**FINDINGS AND RECOMMENDATION
OFFICE OF PLANNING AND ZONING
ANNE ARUNDEL COUNTY, MARYLAND**

CASE NUMBER: 2025-0121-V

The applicant is requesting a variance to allow a dwelling addition (deck) with less setbacks than required on property located at 918 Bay Front Avenue in North Beach.

ADDRESS: 918 Bay Front Ave, North Beach, MD 20714, USA

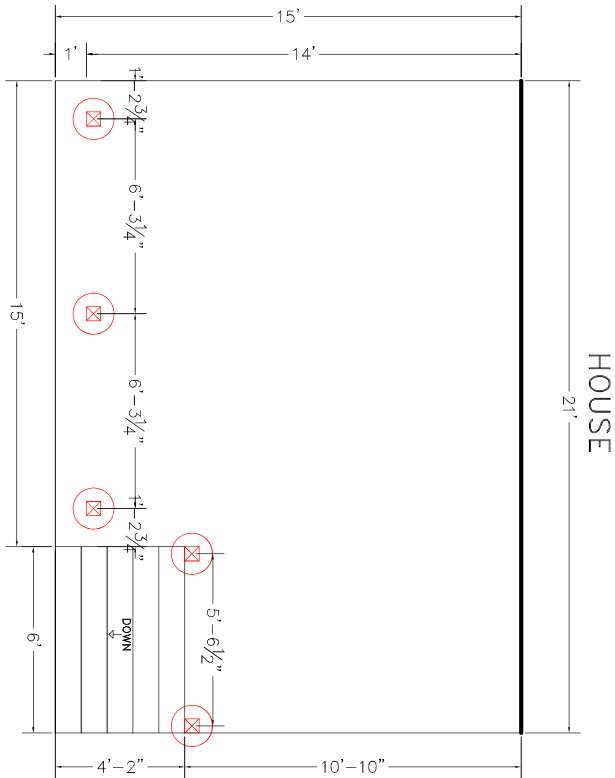
§ 18-4-701 of the Anne Arundel County Zoning Code provides that a principal structure in an R5 District shall be set back a minimum of 25 feet from the front lot line.¹ The proposed deck would be constructed five feet from the front lot line, necessitating a variance of 20 feet.

Approval of the variance would not alter the essential character of the neighborhood, substantially impair the appropriate use or development of adjacent property, or be detrimental to the public welfare. However, while this Office recognizes that some setback relief is warranted, the minimum variance necessary would be that which allows a 12-foot deep deck, in order to remain comparable to the depth of the decks on the four closest waterfront lots.

Based upon the standards set forth in § 18-16-305 of the Code under which a variance may be granted, this Office recommends a ***modified approval*** of a zoning variance to § 18-4-701 of 17 feet to the minimum 25 foot front setback requirement to allow a 12' by 21' (252 square foot) deck with steps to be constructed eight feet from the front lot line.
